Project: **134-140 MARSDEN STREET,  
PARRAMATTA (V BY CROWN)**

Report: **BCA ASSESSMENT REPORT**

Document: **103823-BCA-r2**

Date: 10<sup>th</sup> September 2012

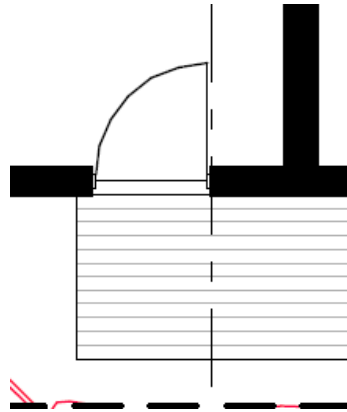
- g) Circulation/turning space in accordance with Clause 6.5 of AS1428.1-2009, for wheelchair turn on the walkways associated with the archaeology, where the walkway crosses to the display area as indicated below.

The corridor/walkway is to be not less than 1500mm wide and 1500mm long in the direction of travel. The space may be splayed as shown below.
